Access Compliance Report

Intersection ID: 16266	Main Street: BEVERLY_DR	Cross Street: PORTLAND_AV	Location:	E
ADA ID: EBE516D8463E	Ramp Type: Perp	Initial Pass/Fail: Fail	Overall Compliance: No	Severity Score: 12.5
Codes/Mitigation Info/Possible Solution		Field Measurements/Component Compliance

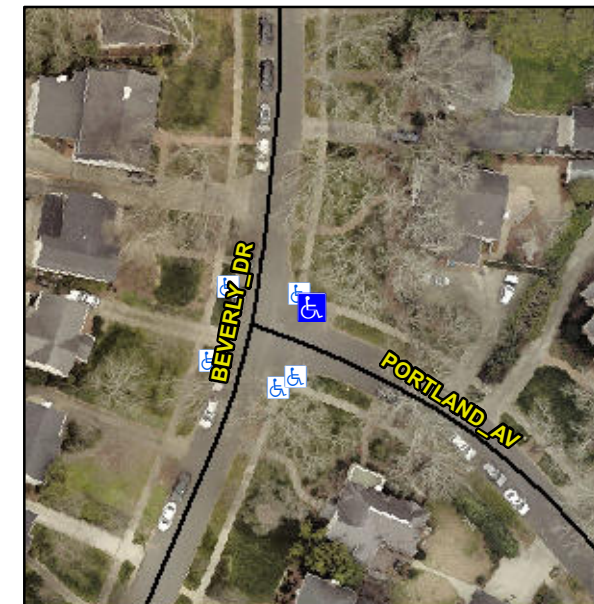
Possible Solutions:

Remove & Replace Entire Ramp.

PROW/ADA:

Not Found, R304.2.2

Compliance	Description	Data	Compliance	Description	Data
N/A	Ramp Length (in)	42.0	No	Ramp Slope (%)	8.8
Yes	Ramp Width (in)	114.0	Yes	Ramp XSlope (%)	0.4
N/A	Flare Type LT	N/A	N/A	Flare Type RT	N/A
N/A	Flare Slope LT (%)	N/A	N/A	Flare Slope RT (%)	N/A
N/A	Flare Traversable LT?	N/A	N/A	Flare Traversable RT?	N/A
N/A	Landing Length (in)	N/A	N/A	DWS Provided?	N/A
N/A	Landing Width (in)	N/A	N/A	DWS Contrast?	N/A
N/A	Landing Slope (%)	N/A	N/A	DWS Length (in)	N/A
N/A	Landing X Slope (%)	N/A	N/A	DWS Full Width?	N/A
N/A	Landing Curb? (Y/N)	N/A	N/A	DWS Offset (in)	N/A
N/A	Shared Landing?	N/A			
N/A	Gutter Ponding?	N/A	N/A	Gutter Slope (%)	N/A
N/A	Gutter Lip Ht (in)	N/A	N/A	Gutter X Slope (%)	N/A
N/A	Painted X Walk1?	No	N/A	Painted X Walk2?	N/A
	X Walk 1 Direction	To SW		X Walk 2 Direction	N/A
N/A	X Walk 1 Width (in)	N/A	N/A	X Walk 2 Width (in)	N/A
	X Walk 1 Slope (%)	3.2		X Walk 2 Slope (%)	N/A
	X Walk 1 X Slope (%)	3.1		X Walk 2 X Slope (%)	N/A
